# Access Compliance Report

## Public Rights-of-Way

### (Curb Ramps)

Intersection ID: N/A	Main Street: BYRUM_DR	Cross Street: COOLEMEE_DR	Location: SE
ADA ID: 4084C4F10B04	Ramp Type: Perp	Initial Pass/Fail: Fail	Overall Compliance: No
		Severity Score: 12.5

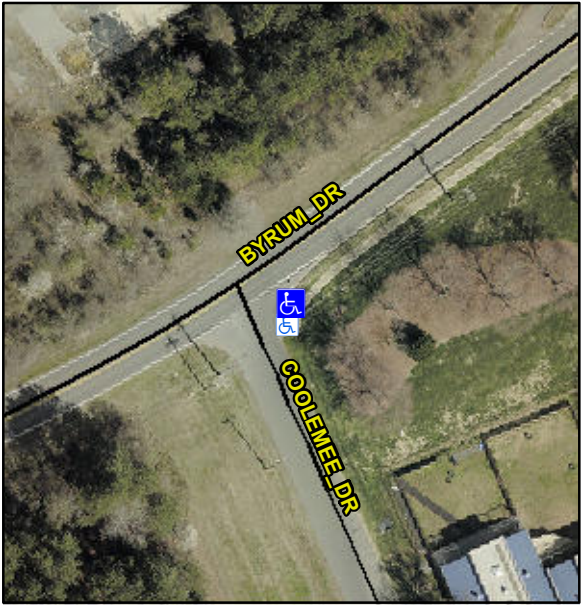
Codes/Mitigation Info/Possible Solution			Field Measurements/Component Compliance			
	Possible Solutions:		<b>Compliance</b>	<b>Description</b>	<b>Data</b>	
	<b>Remove &amp; Replace Entire Ramp.</b>		N/A	Ramp Length (in)	64.0	<b>Yes</b>
			Yes	Ramp Width (in)	48.0	<b>No</b>
			N/A	Flare Type LT	N/A	<b>N/A</b>
			N/A	Flare Slope LT (%)	N/A	<b>N/A</b>
			N/A	Flare Traversable LT?	N/A	<b>N/A</b>
			N/A	Landing Length (in)	N/A	<b>N/A</b>
			N/A	Landing Width (in)	N/A	<b>N/A</b>
			N/A	Landing Slope (%)	N/A	<b>N/A</b>
			N/A	Landing X Slope (%)	N/A	<b>N/A</b>
			N/A	Landing Curb? (Y/N)	N/A	<b>N/A</b>
			N/A	Shared Landing?	N/A	
			N/A	Gutter Ponding?	N/A	<b>N/A</b>
			N/A	Gutter Lip Ht (in)	N/A	<b>N/A</b>
			N/A	Painted X Walk1?	No	<b>N/A</b>
				X Walk 1 Direction	To N	
			N/A	X Walk 1 Width (in)	N/A	<b>N/A</b>
				X Walk 1 Slope (%)	1.5	
				X Walk 1 X Slope (%)	1.2	
			N/A	Ramp inside XWalk1?	N/A	<b>N/A</b>
<p>Surveyor Notes:</p> <p><b>N/A</b></p> <p>PROW/ADA:</p> <p><b>Not Found, R304.5.3</b></p>				Ramp Slope (%)	6.5

Ramp XSlope (%)	5.2	
				Flare Type RT	N/A	
				Flare Slope RT (%)	N/A	
				Flare Traversable RT?	N/A	
				DWS Provided?	N/A	
				DWS Contrast?	N/A	
				DWS Length (in)	N/A	
				DWS Full Width?	N/A	
				DWS Offset (in)	N/A	
				Gutter Slope (%)	N/A	
				Gutter X Slope (%)	N/A	
				Painted X Walk2?	N/A	
				X Walk 2 Direction	N/A	
				X Walk 2 Width (in)	N/A	
				X Walk 2 Slope (%)	N/A	
				X Walk 2 X Slope (%)	N/A	
				Ramp inside XWalk2?	N/A	
				Clear Space?	N/A	
				Clear Space to XWalk (in)	N/A	
<p>Total Cost:</p> <p>\$ 1850.00</p>				Storm Grate/Utility Hazard?	N/A	
				Storm Grate/Utility Type	N/A	
					N/A	
				Surface Condition? (G/P)	Good
